PROPOSED MULTI-FAMILY DEVELOPMENT

LOUISE BERRY DRIVE
BROOKLYN, CONNECTICUT

In response to review NECCOG comments on the referenced project dated July, 2020 we offer the following; please note that an additional sheet has been added to the plan set:

PROPERTY SURVEY

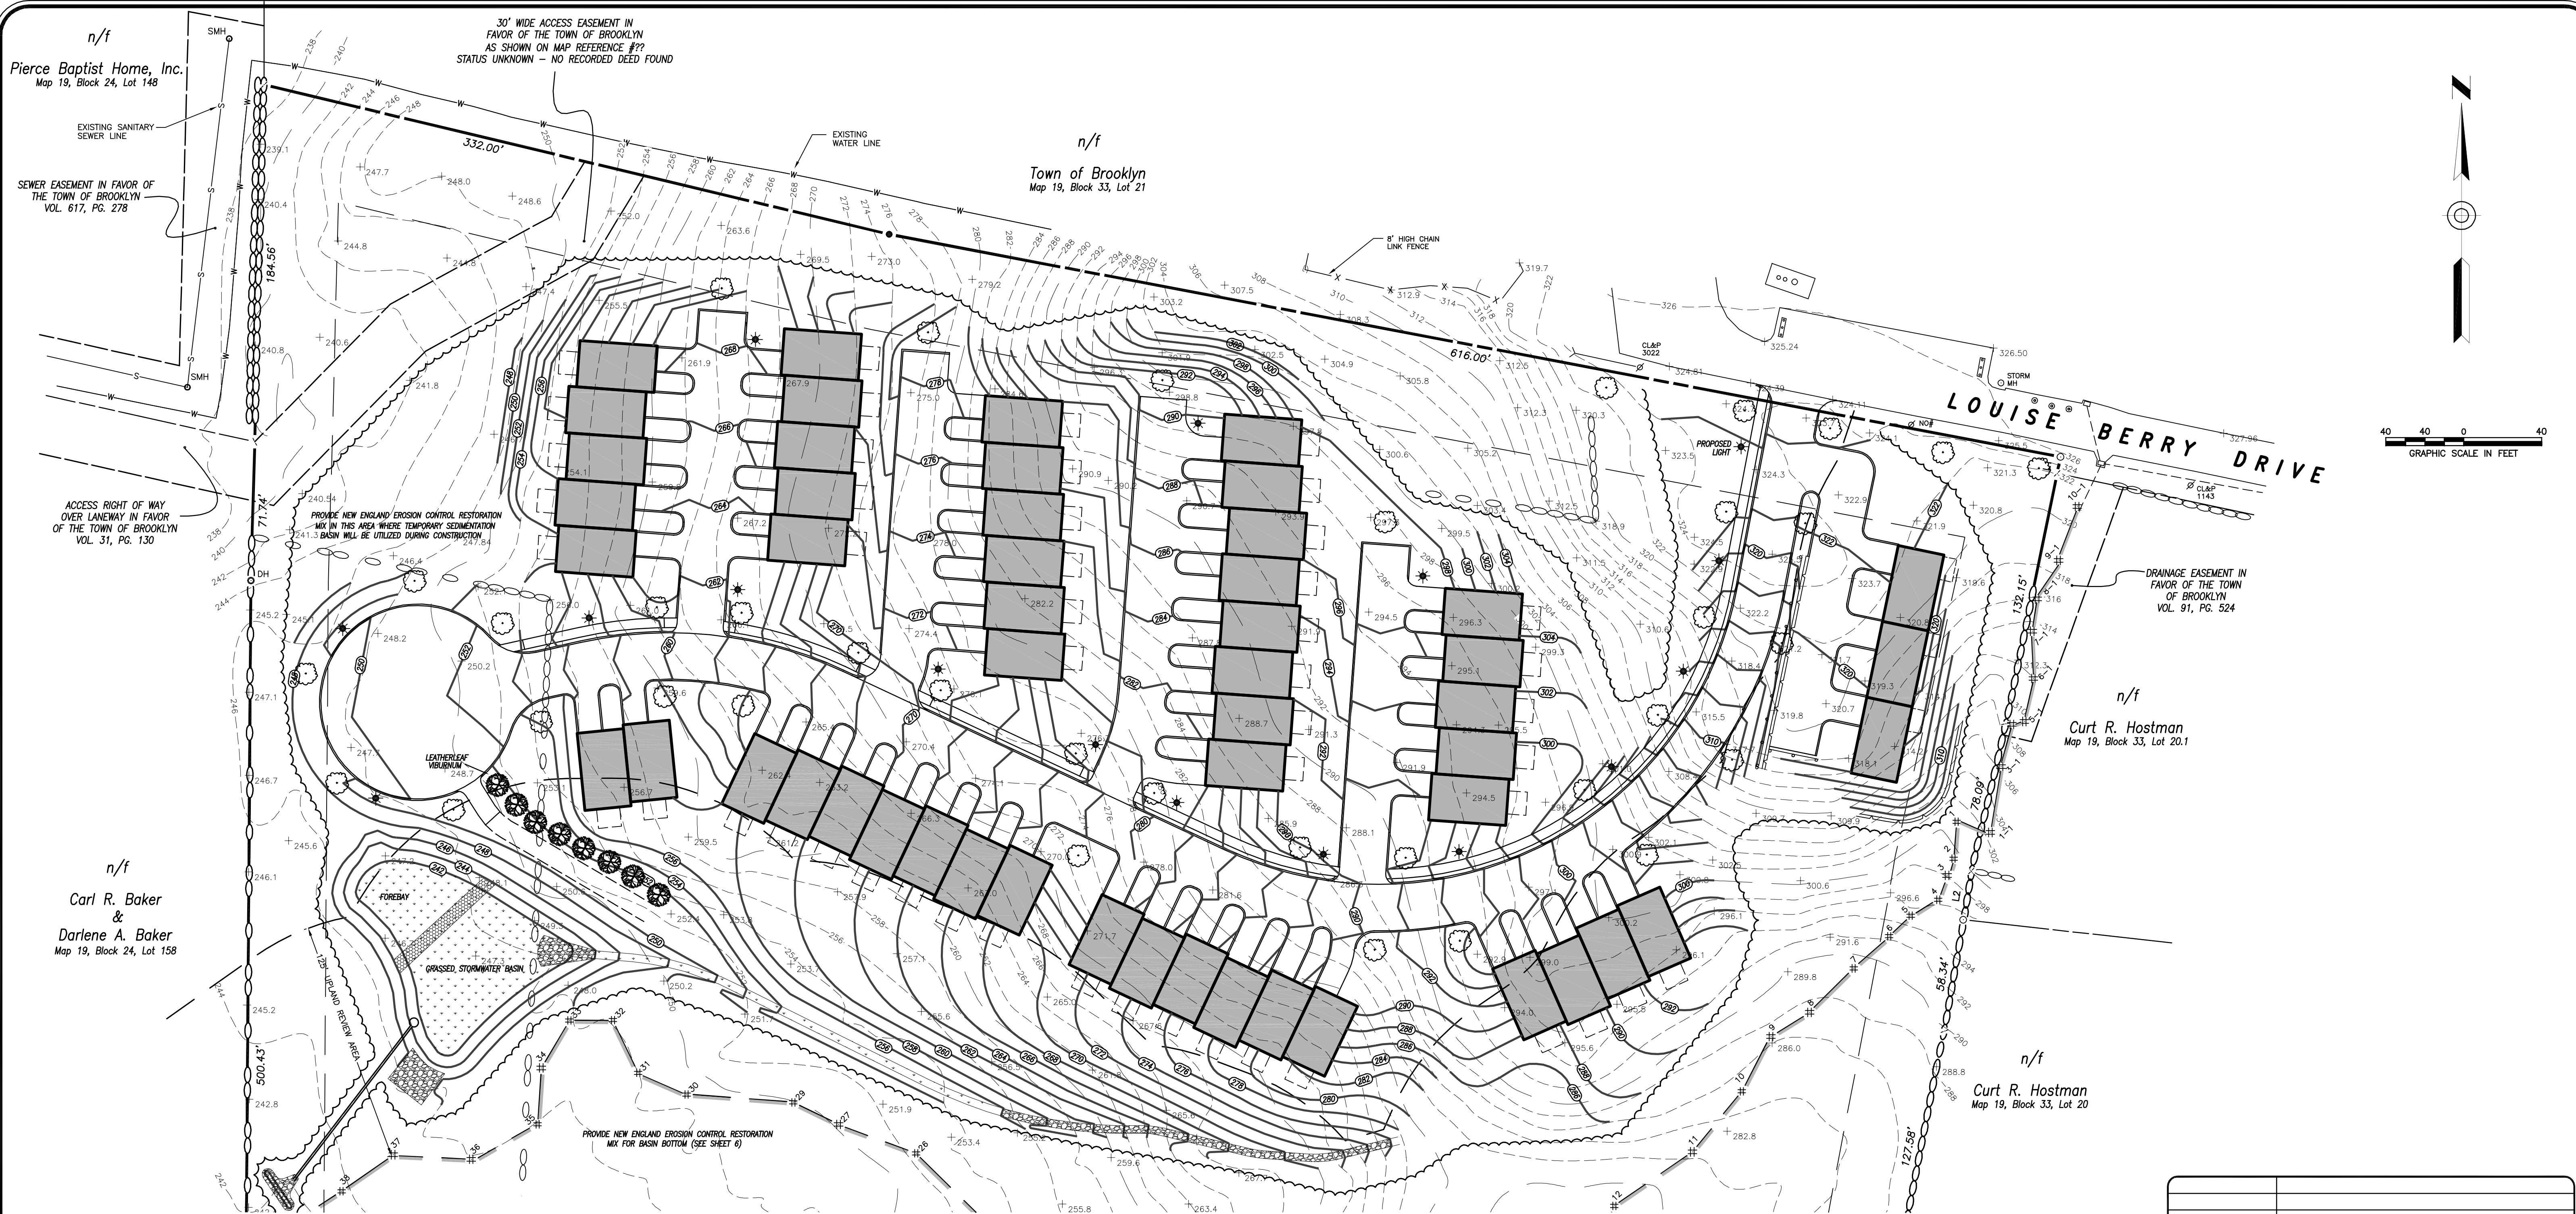
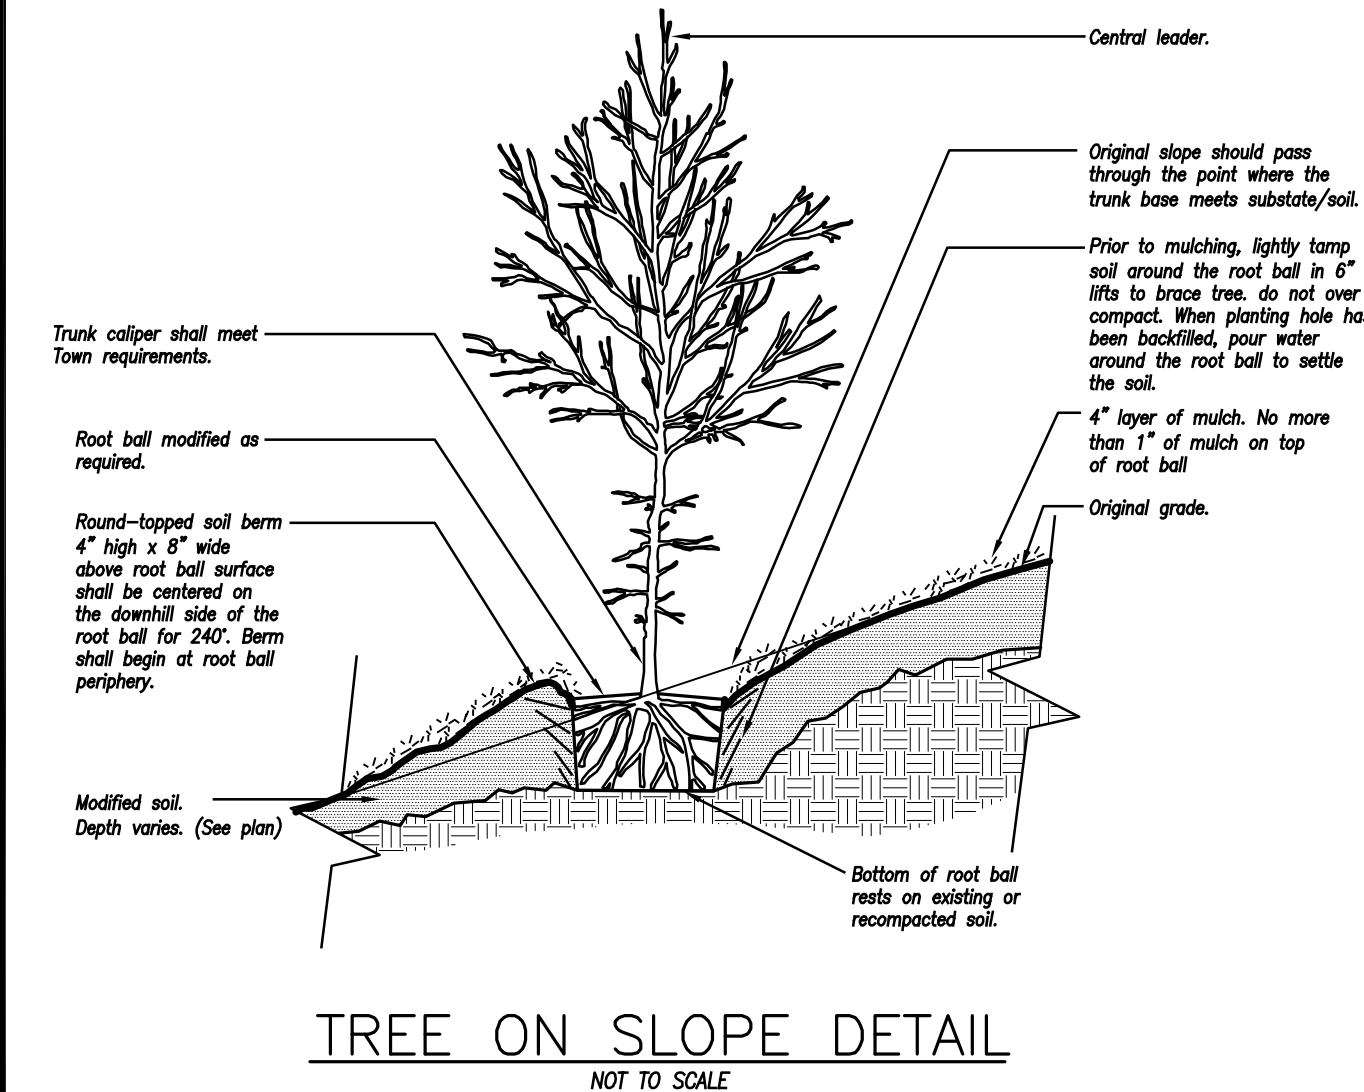
Sheet 2 of 9

1. The soil Scientists signature block has been added to the plan

LAYOUT & LANDSCAPING PLAN

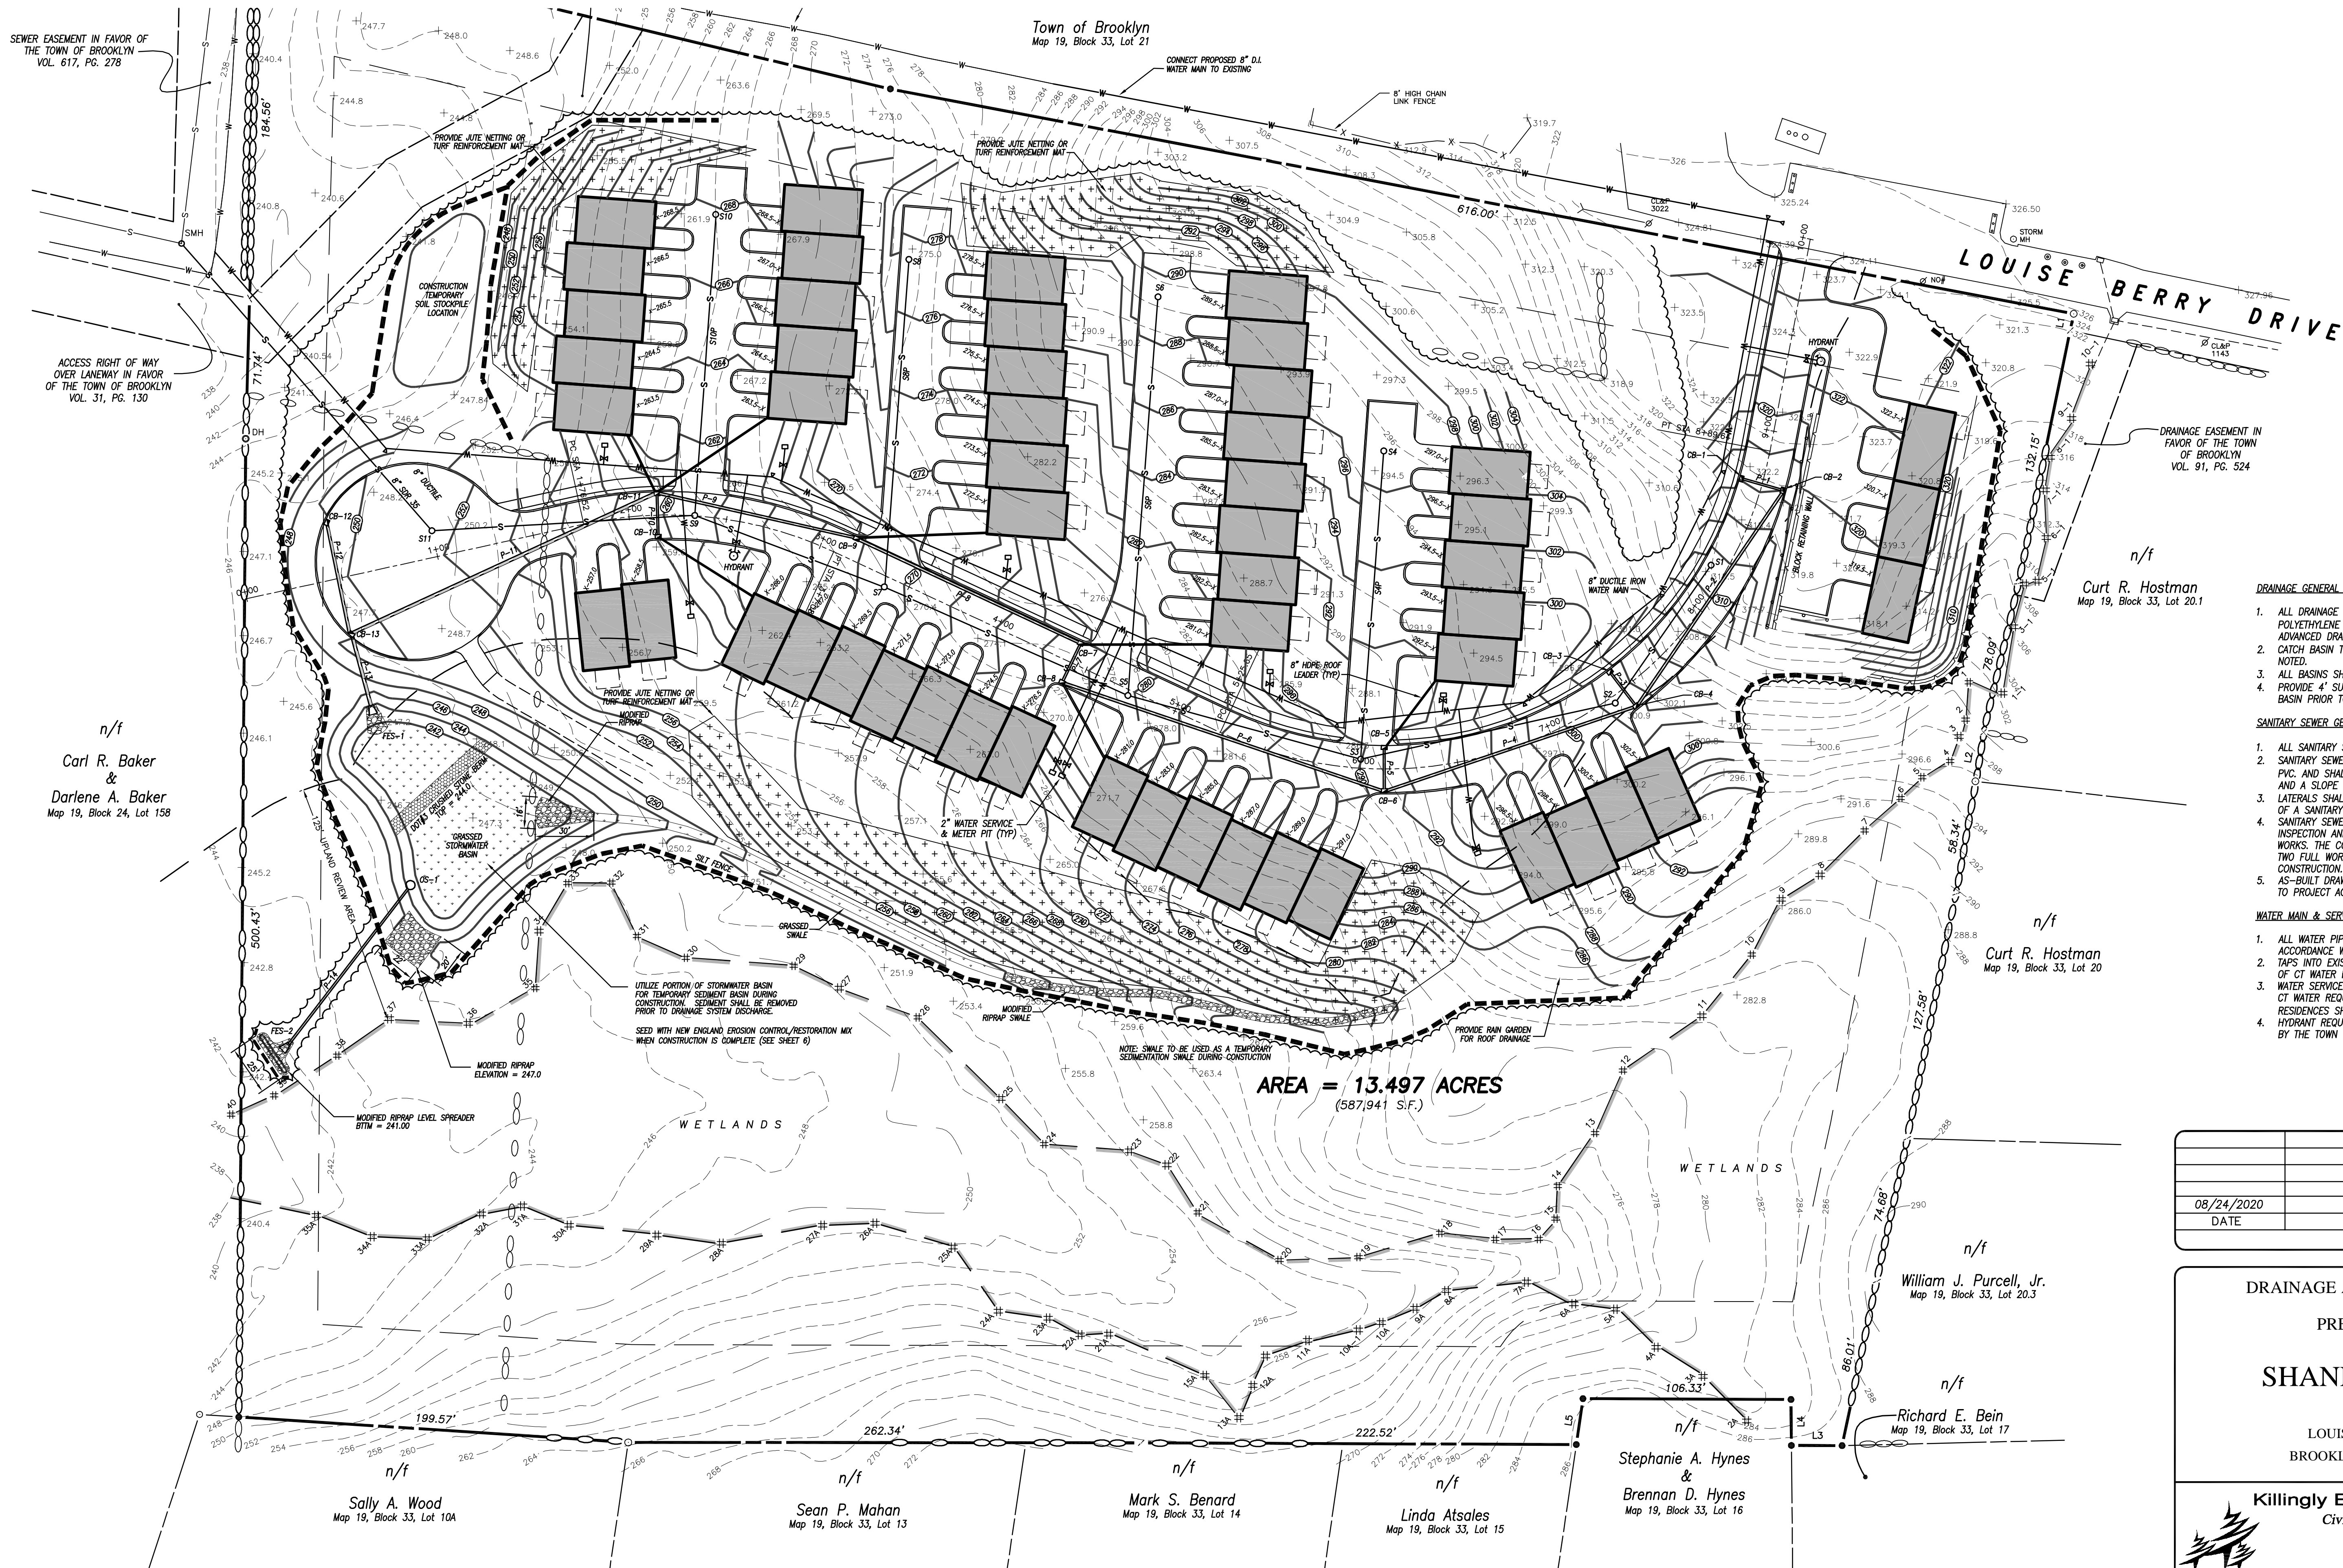
Sheet 4 of 9

1. Light poles have been added to the plans.
2. Restoration of the area where the temporary sedimentation basin has been noted on the plans.
3. Additional landscaping to screen the basin maintenance access has been shown.

CAPE COD CURBING
NOT TO SCALE

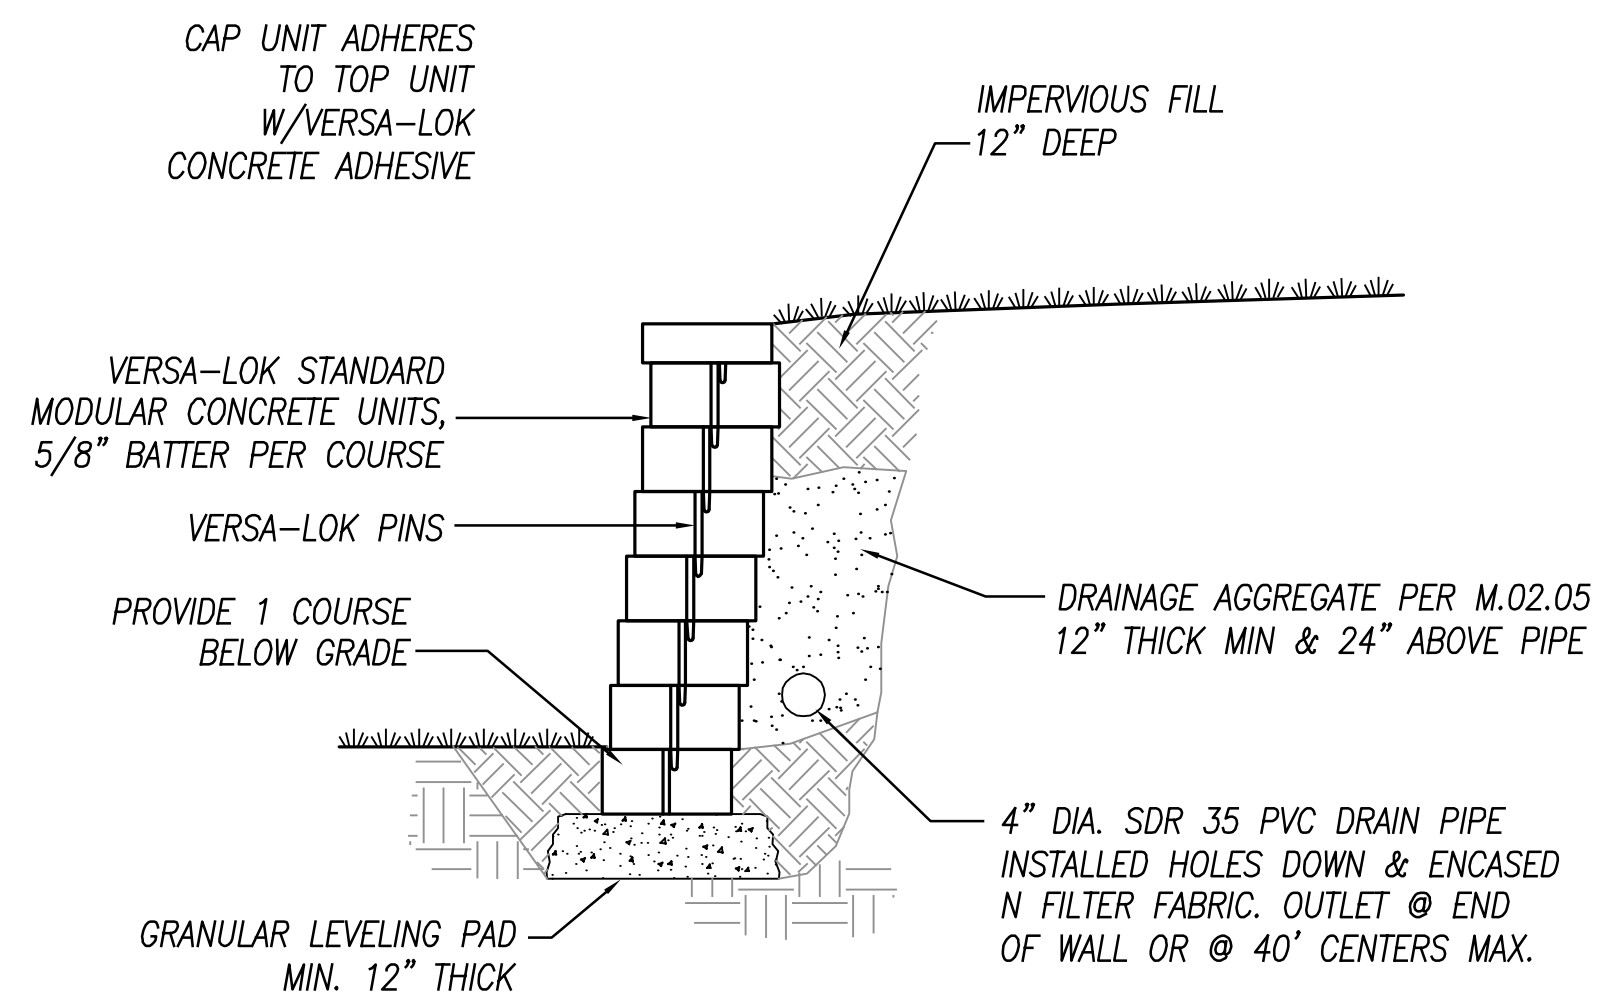
1. Curbing has been modified to a Cape Cod style curb.
2. The type of brick for the sanitary manhole has been specified on the plan.
3. The sanitary sewer pipe in trench detail has been modified accordingly.
4. Kor-N-Seal connections have been specified for the sanitary sewer connections.
5. Specification for the preservative retention and AWP classification of the guide rail has been added to the detail.
6. Guide rail is shown adjacent to the accessible units at the site entrance.
7. Speed limit sign has been modified accordingly.
8. The "No Outlet" sign detail has been modified accordingly.
9. The stop sign detail has been modified accordingly.
10. The retaining wall section has been modified accordingly. It should be noted that the detail was taken from the Versa-Lok website.
11. Roadway detail has been modified accordingly.
12. The sidewalk detail has been modified accordingly.

TYPICAL SECTION-UNREINFORCED RETAINING WALL
VERSA-LOK OR APPROVED EQUAL

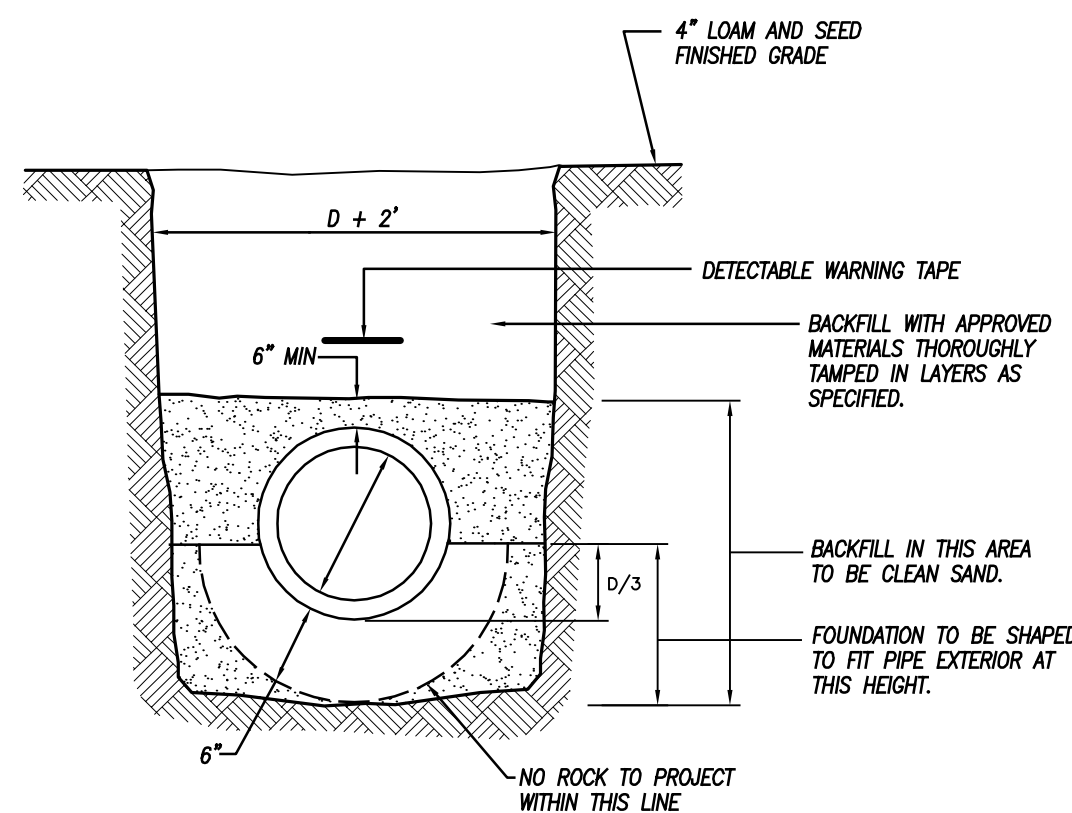
6. Block retaining wall has been labeled as "Versa-Lok or equal". A guide rail has been added at the top of the wall.
7. Curbing has been shown around the landscaped islands for units 1-3.
